Technical Service Bulletin Number	Revision Level	Date	Group Number
TSB140071

Fault Code 2198 Caused by Original Equipment Manufacturer (OEM) Keyswitch Wiring

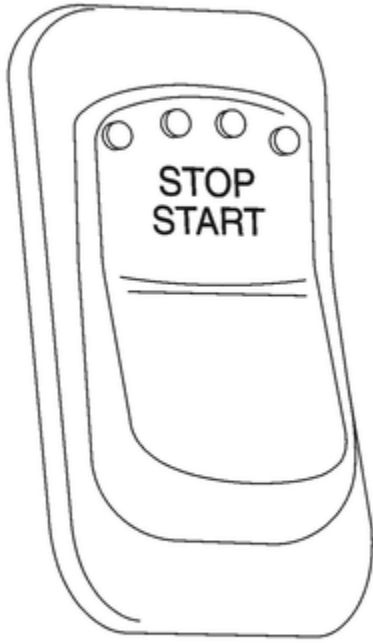
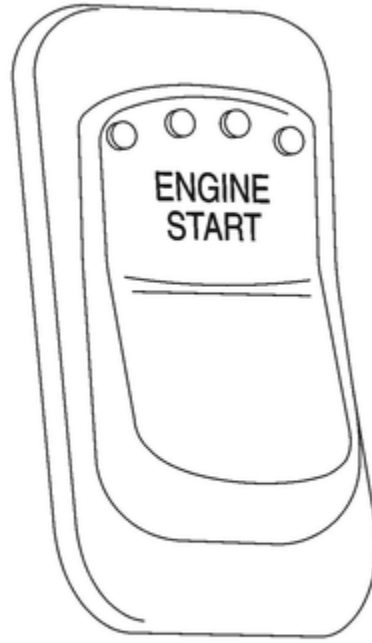
Pictured below are the previous and revised switches for reference. Also pictured below is the location of the switch configuration on the dash of Emergency One vehicles.

If a customer experiences Fault Code 2198 on an Emergency One fire apparatus, check the unit's keyswitch configuration. If the previous configuration is used, this can be the cause of Fault Code 2198. If the revised configuration is used, the keyswitch configuration is likely **not** the cause of Fault Code 2198. Follow the published troubleshooting for Fault Code 2198.

To prevent repeat occurrences of Fault Code 2198 and unnecessary replacement of parts, Emergency One has revised the keyswitch wiring on certain vehicles with specific optional equipment.
